Access Compliance Report

Public Rights-of-Way

Intersection ID: 20439	Main Street: FAIRVIEW_RD	Cross Street: SHARON_RD	Location: SW
ADA ID: FFD49840EB73	Ramp Type: Perp	Initial Pass/Fail: Fail	Overall Compliance: No
		Severity Score: 12.5

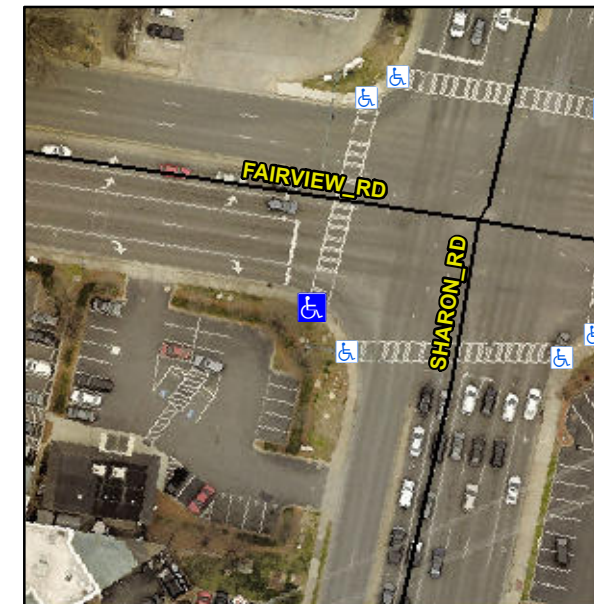
Not Found, R304.2.2

Compliance	Description	Data	Compliance	Description	Data
N/A	Ramp Length (in)	60.0	No	Ramp Slope (%)	9.1
Yes	Ramp Width (in)	48.0	Yes	Ramp XSlope (%)	1.7
N/A	Flare Type LT	N/A	N/A	Flare Type RT	N/A
N/A	Flare Slope LT (%)	N/A	N/A	Flare Slope RT (%)	N/A
N/A	Flare Traversable LT?	N/A	N/A	Flare Traversable RT?	N/A
N/A	Landing Length (in)	N/A	N/A	DWS Provided?	N/A
N/A	Landing Width (in)	N/A	N/A	DWS Contrast?	N/A
N/A	Landing Slope (%)	N/A	N/A	DWS Length (in)	N/A
N/A	Landing X Slope (%)	N/A	N/A	DWS Full Width?	N/A
N/A	Landing Curb? (Y/N)	N/A	N/A	DWS Offset (in)	N/A
N/A	Shared Landing?	N/A			
N/A	Gutter Ponding?	N/A	N/A	Gutter Slope (%)	N/A
N/A	Gutter Lip Ht (in)	N/A	N/A	Gutter X Slope (%)	N/A
N/A	Painted X Walk1?	Yes	N/A	Painted X Walk2?	N/A
	X Walk 1 Direction	To NE		X Walk 2 Direction	N/A
N/A	X Walk 1 Width (in)	112.0	N/A	X Walk 2 Width (in)	N/A
	X Walk 1 Slope (%)	0.6		X Walk 2 Slope (%)	N/A
	X Walk 1 X Slope (%)	0.0		X Walk 2 X Slope (%)	N/A

Remove & Replace Entire Ramp.
